Access Compliance Report

Public Rights-of-Way

(Curb Ramps)

Intersection ID: 9779	Main Street: CAMPUS_ST	Cross Street: CEMETERY_ST	Location: NE
ADA ID: E650A2307DA2	Ramp Type: PerpDiag	Initial Pass/Fail: Fail	Overall Compliance: No
		Severity Score: 22.5

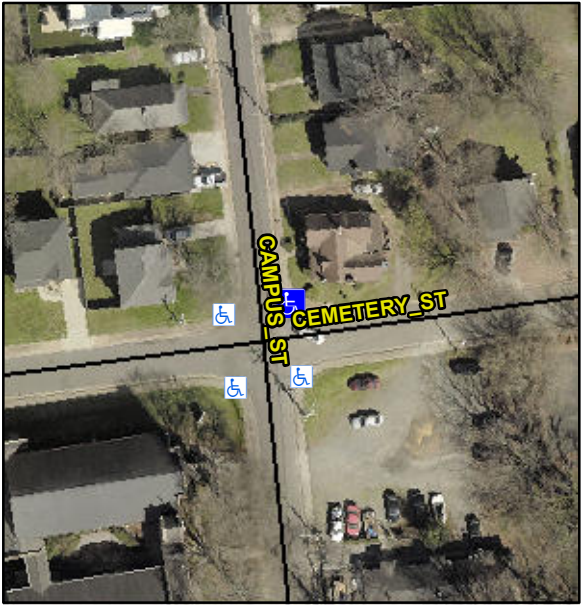
Codes/Mitigation Info/Possible Solution			Field Measurements/Component Compliance		
	Possible Solutions:		Compliance	Description	Data
	Remove & Replace Curb Ramp With Two New Directional Ramps or Equivalent.		No	Ramp Length (in)	46.0
			No	Ramp Width (in)	44.0
			N/A	Flare Type LT	N/A
			N/A	Flare Slope LT (%)	N/A
			N/A	Flare Traversable LT?	N/A
			N/A	Landing Length (in)	N/A
			N/A	Landing Width (in)	N/A
			N/A	Landing Slope (%)	N/A
			N/A	Landing X Slope (%)	N/A
<p>Surveyor Notes:</p> <p>N/A</p> <p>PROW/ADA:</p> <p>Not Found, R304.5.1, R304.2.2, R304.5.3</p>			N/A	Flare Type RT	N/A
			N/A	Flare Slope RT (%)	N/A
			N/A	Flare Traversable RT?	N/A
			N/A	DWS Provided?	N/A
			N/A	DWS Contrast?	N/A
			N/A	DWS Length (in)	N/A
			N/A	DWS Full Width?	N/A
			N/A	DWS Offset (in)	N/A
			N/A	Shared Landing?	N/A
			N/A	Gutter Ponding?	N/A
<p>Total Cost:</p> <p>\$ 3200.00</p>			N/A	Gutter Lip Ht (in)	N/A
			N/A	Painted X Walk1?	No

X Walk 1 Direction	To W
			N/A	X Walk 1 Width (in)	N/A
				X Walk 1 Slope (%)	1.6
				X Walk 1 X Slope (%)	0.9
			N/A	Ramp inside XWalk1?	N/A
				Road Slope (%)	2.2
				Road X Slope (%)	2.7
			N/A	Any Obstructions?	N/A
				Obstruction Type	
			N/A		N/A
				Storm Grate/Utility Hazard?	N/A
				Storm Grate/Utility Type	
			N/A		N/A
			Yes	Surface Condition? (G/P)	Good
